Amended Submission - Reserved Matters Application at Lower Broadbridge Farm, Broadbridge Heath

Appendix 1 – Full Response to Landscape Officers Comments Dated 11 June 2026

Appendix 2 – Full Response to LLFA Comments Dated 27 May 2026

Re: Response to LLFA Objection – DC/26/0592 – Land at Lower Broadbridge Farm, Billingshurst Road, Broadbridge Heath, Horsham, West Sussex, RH12 3LR

Title
**SURFACE WATER FLOODING
EXCEEDANCE PLAN**

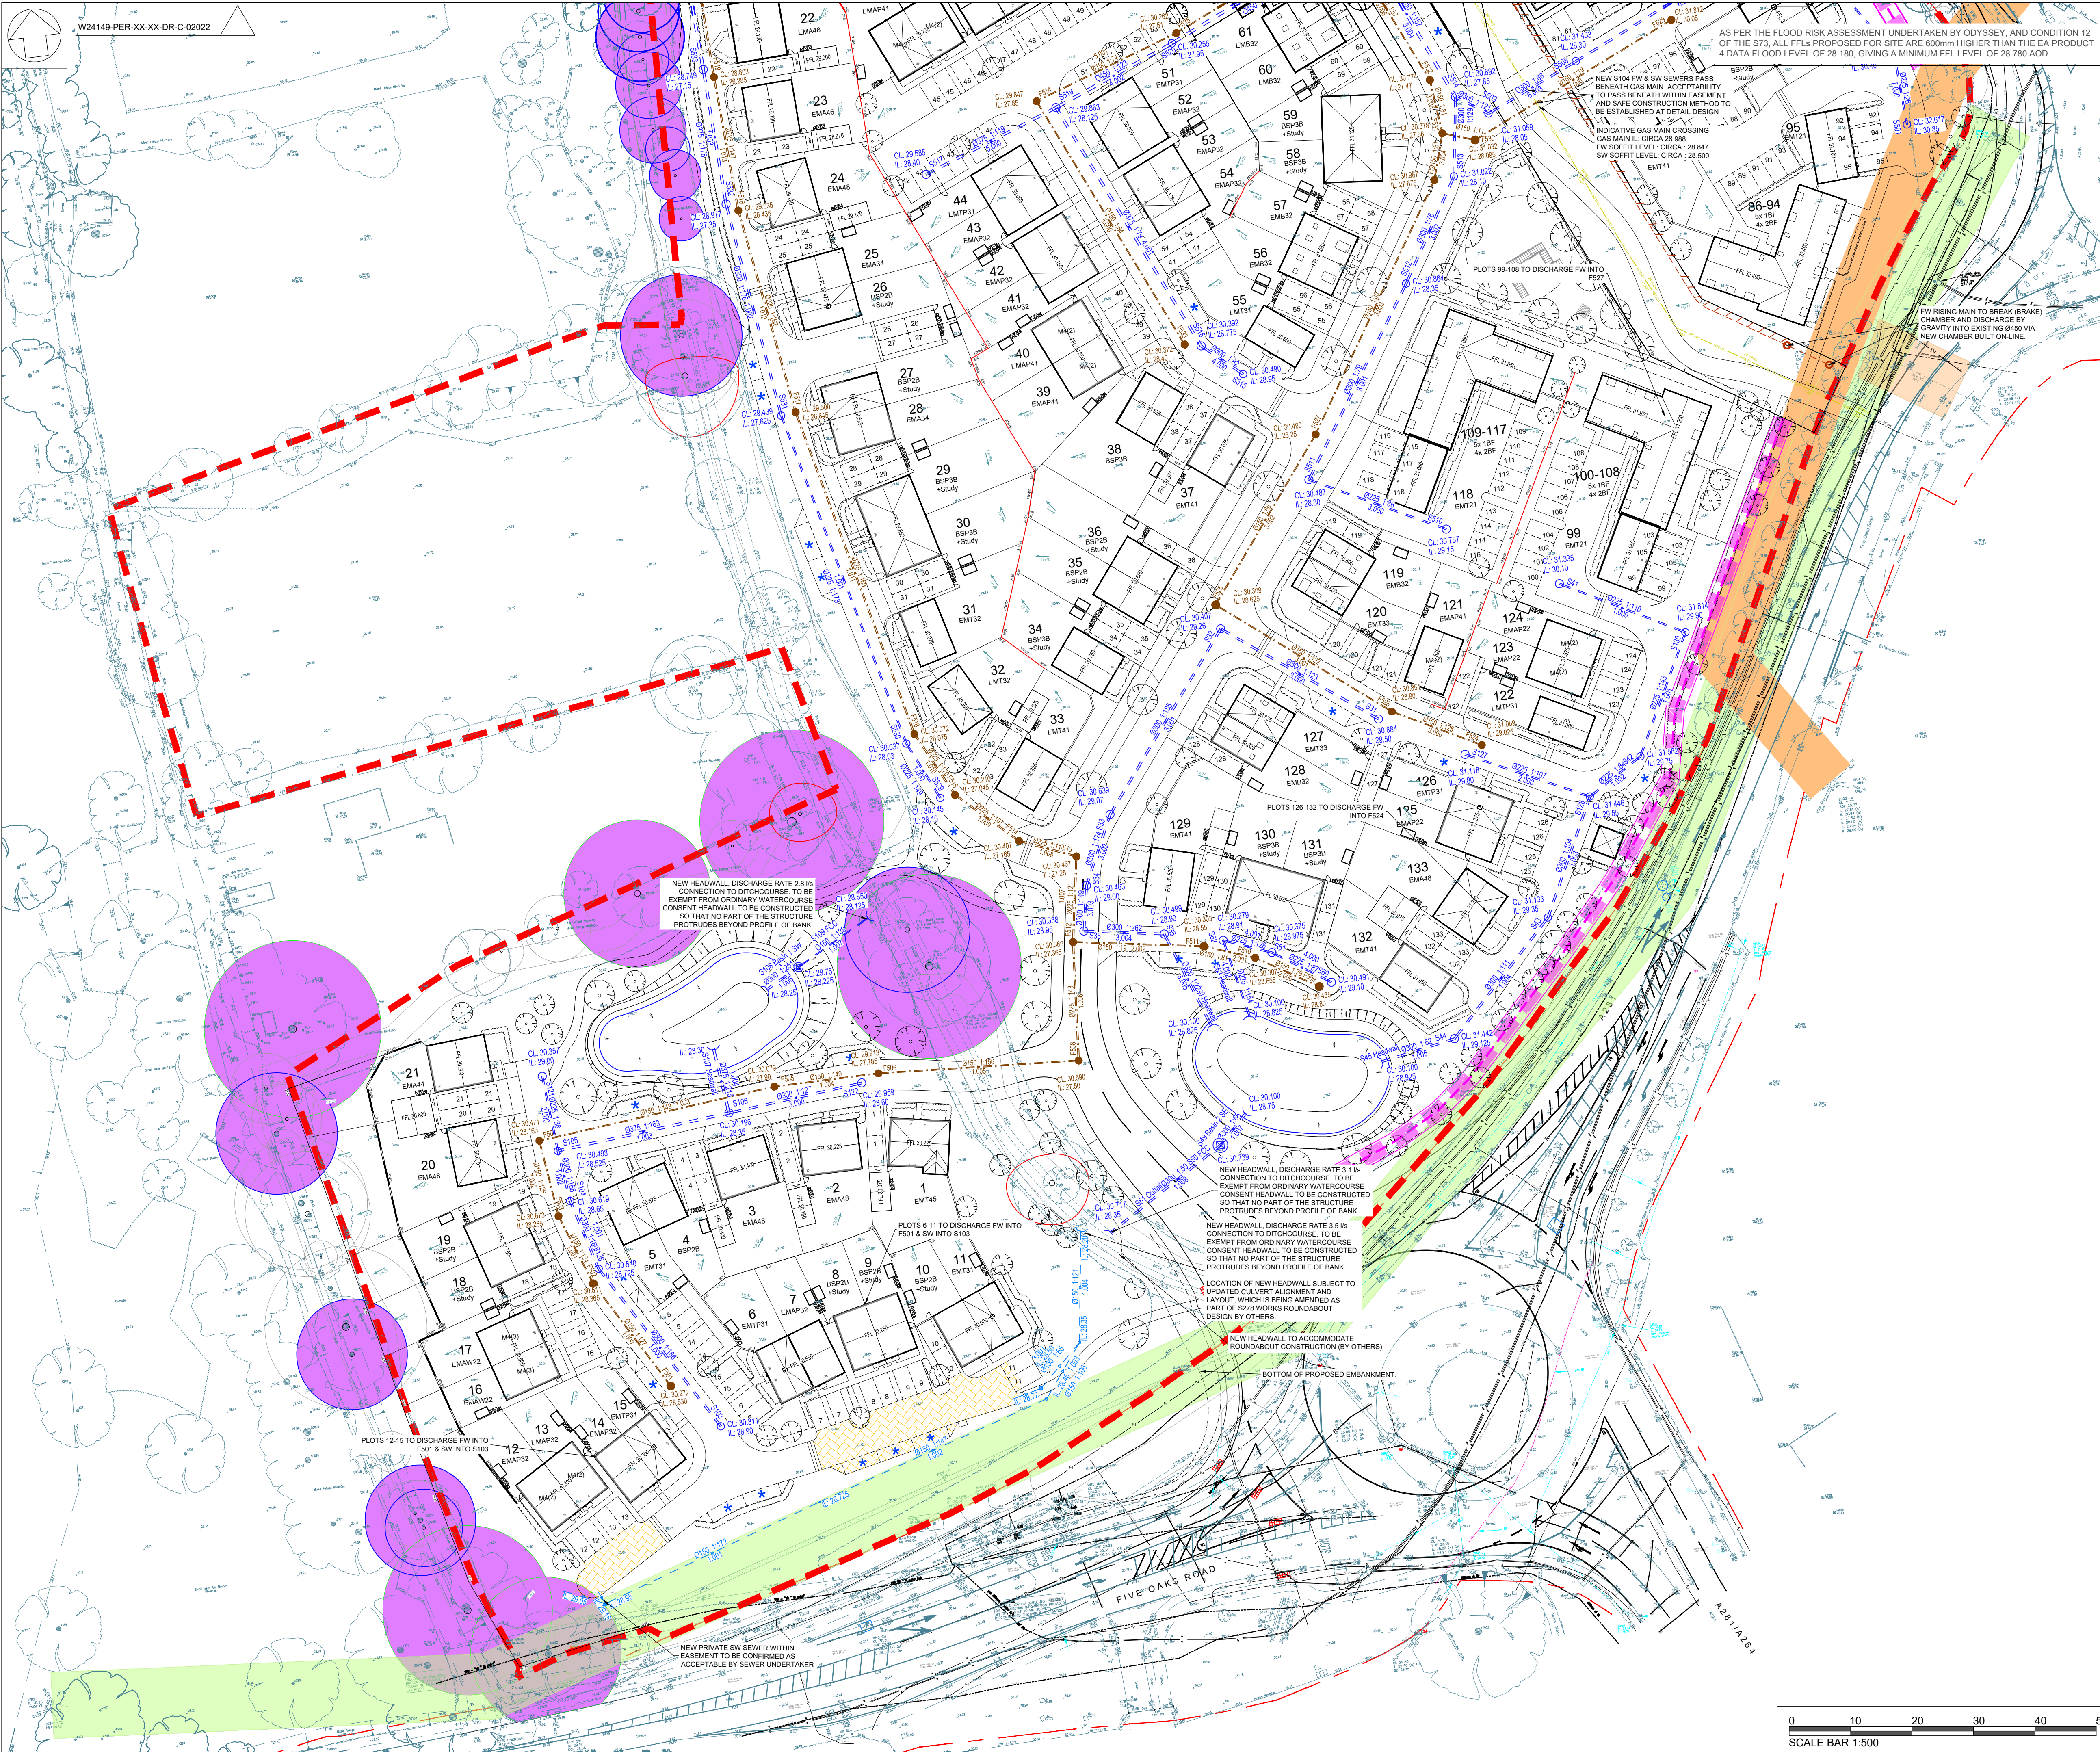
Item	LLFA Objection	Perega Response	Status
1	Evidence of the Applicant's conformity with Standard 1, Priority 1 of the National Standards for SuDS (collection for non-potable use), as West Sussex is classified as a water stressed area.	The Outline scheme was consented prior to the publication of the National SUDS standards, which the FRA is pursuant to. The scheme has been developed without the inclusion of water butts or rain water harvesting.	
2	Please could we be provided with an updated drainage strategy layout, inclusive of the following. There appear to be a headwall to basin (S528) seemingly not in the bank, and the discharge headwall for this basin may be outside the redline boundary:	Please see included updated drawings. Drawings "W24149-PER-XX-XX-DR-C-02021 P7" and "W24149-PER-XX-XX-DR-C-02022 P7". Headwall locations have been amended to accommodate the watercourse layout and the updated basin layouts.

P02	UPDATED TO ACCOMMODATE UPDATED SITE LAYOUT AND POND LAYOUT	GS	18/08/2026	ACN
P01	ISSUED FOR INFORMATION	RGM	08/07/2026	GS
Rev	Description	By	Date	Chkd

Project BROADBRIDGE FARM HORSHAM					
Title GAS MAIN LAYOUT DRAINAGE SECTIONS					
Perega Project No.	W24149	Checked	-	Passed	-
Size	A1	Scale	1:500		
Project Code	W24149	Originator	PER	Zone	XX
Level	XX	Type	SK	Role	C
Drawing No.	00024	Suitability Code	S2	Status	INFORMATION
Revision	P02

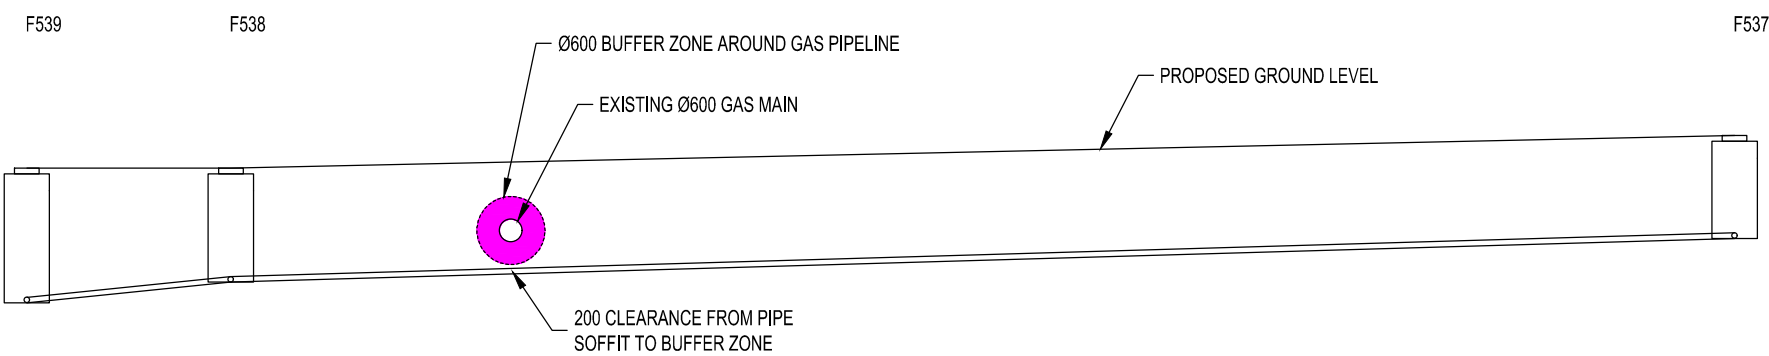
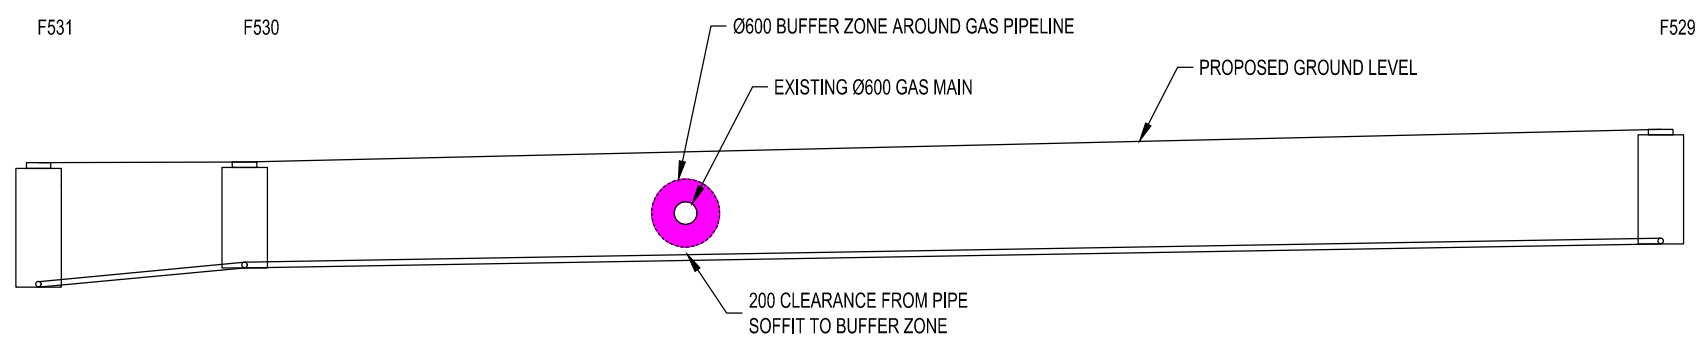
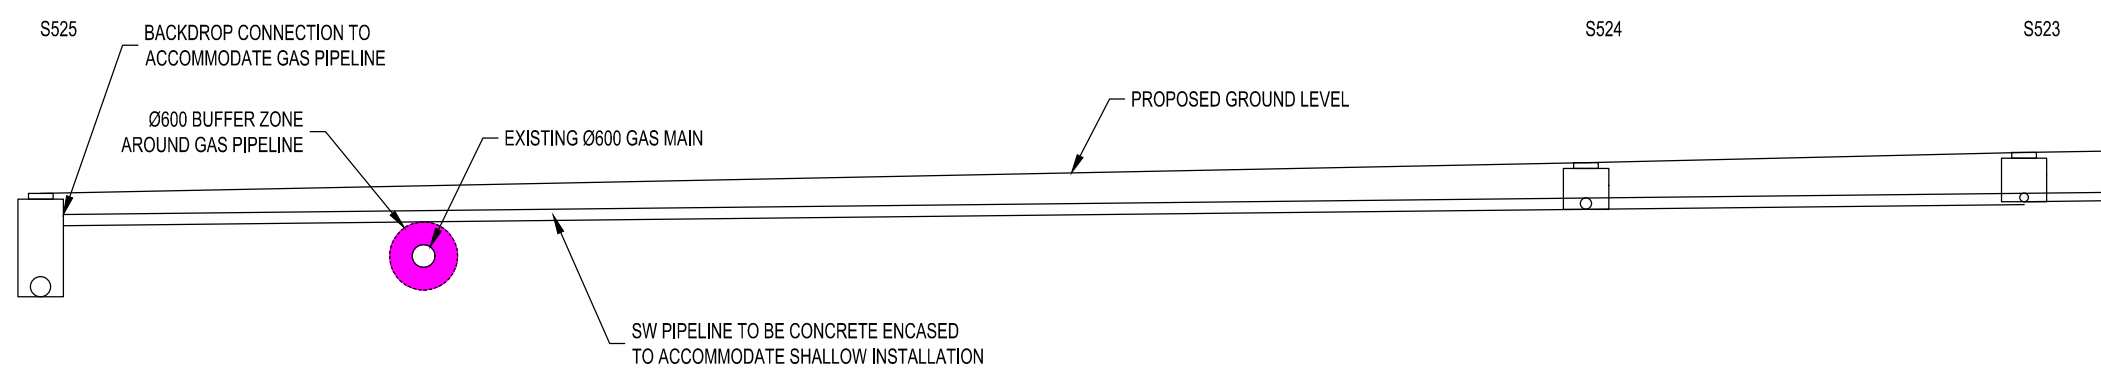
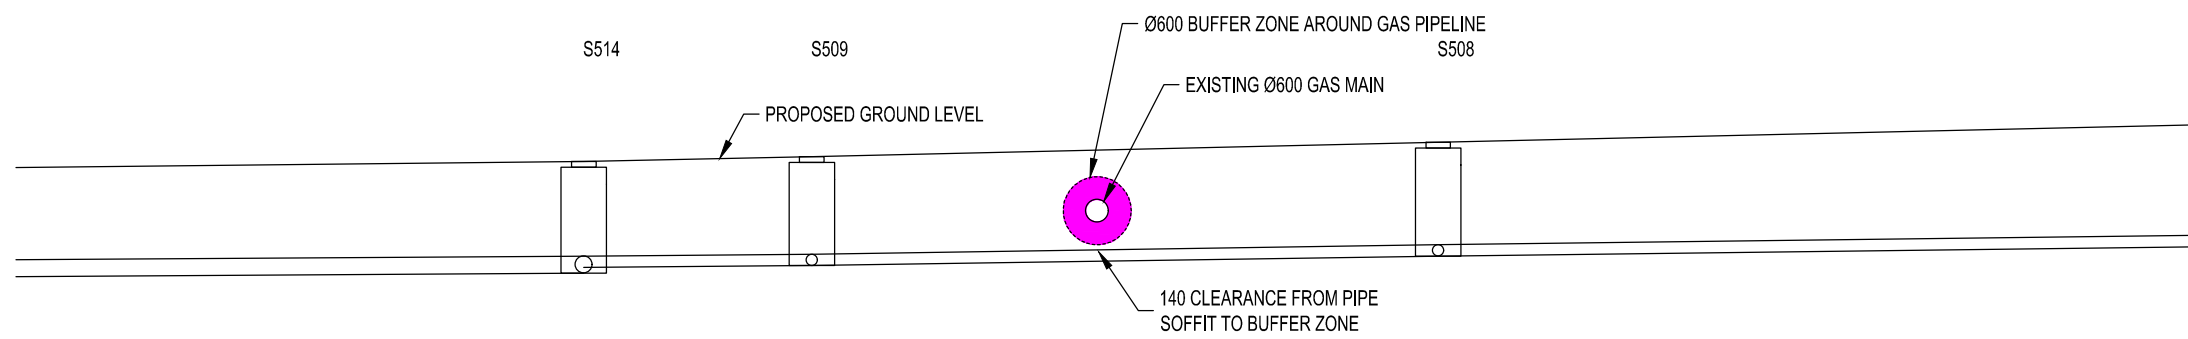
2d	Any structures, including any culverting required for access purposes, subject to Ordinary Watercourse Consent to be labelled if applicable (see below advisory note).	We have engaged the council and had a kick-off meeting to discuss the requirements for the OWC applications. These discussions will continue once RM planning is granted.	Ongoing
2e	An exceedance route plan (this can be a separate document if required)	Please see attached drawing "W24149-PER-XX-XX-SK-C-00019 P2" for information	
2f	We also note there will be amendments to the existing watercourse, please ensure the plan includes the updated course as proposed:	There are no proposed amendments to the alignment of the existing watercourse. The only change proposed is to extend the culvert which discharges from the existing road to the watercourse to accommodate the new roundabout arm construction. This OWC application is being progressed by the consultant responsible for the roundabout design. We have included the layout and location of the proposed new headwall location and the extent of the embankment works to accommodate the new

P02	UPDATED TO ACCOMMODATE UPDATED SITE AND POND LAYOUTS. ISSUED FOR INFORMATION	GS	18/08/2026	ACN
P01	ISSUED FOR INFORMATION	GS	08/07/2026	ACN
Rev	Description	By	Date	Chkd
